SLR Project No.: 402.064843.00001

**RE: Discharge of conditions 20 and 21 of full planning permission F/19/86233
Land to the North and East of Boorley Green, Winchester Road, Botley, SO32
2UA**

SLR Consulting have been requested to provide additional information for conditions 20 and 21, to support application reference: DC/22/94320.

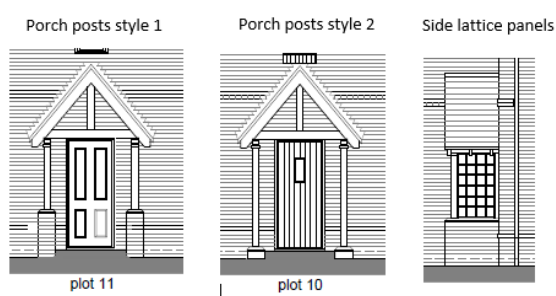
- *Drawing 540316-0235 rev A “Apex Canopy 45° - 1800x600 – Avon Ready to Tile” needs to be amended to show the materials, including their colour, to be used in the construction of the porch and to also include details (dimensions, materials and colour) of the different style of porch posts and side lattice panels where proposed (see below). Alternatively additional drawings could be submitted to provide this information.*

Porch Styles

Two styles of porches are to be used on the site and these are detailed on drawing B1008-CDP-XXXXXX-RD-D2-A-AS-0322 Rev 01, as attached. The drawings state the materials to be used and the relevant colours.

HT203 Plots 1021, 1022, 1025, 1026, 1027, 1035, 1037, 1038, 1039. HT350 Plots 1013, 1014, 1018, 1019 - Lead effect flat door canopy.

HT304 Plot 1011. HT305i Plots 1010, 1023, 1024, 1034, 1040 - Apex canopy 45 degrees.

Block A, Block B, Block C x2 (w/ 2x posts), Block D (inc 2x gallows) Block E (w/ 2x posts). Pitched canopy 40 degrees.

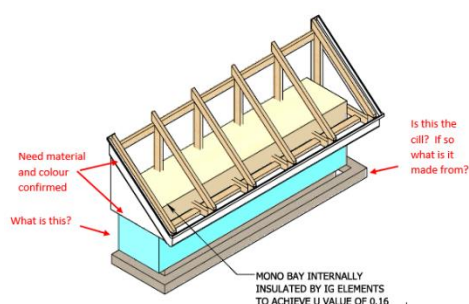
- *Details of the pitched roof dormer window style that breaks the eaves line on plots 15-17 (see below) are required as none have been provided. I note your letter of 6.11.23 states that they are to be of a GRP design, but a plan detail is required, as has been provided for the flat roof dormer than breaks the eaves. I note you have submitted drawing LIND160521-SW/SD-DOR-02 rev C1 “Canopy Details – GRP Pitched Roof Dormer Detail”, but this is for a full dormer, rather than one that breaks the eaves.*

Pitched Roof Dormer

Please see submitted drawing B1008-CDP-XXXXXX-RD-D2-A-AS-0318 Rev: 01. Window Frames will be in Grey (RAL 7015).
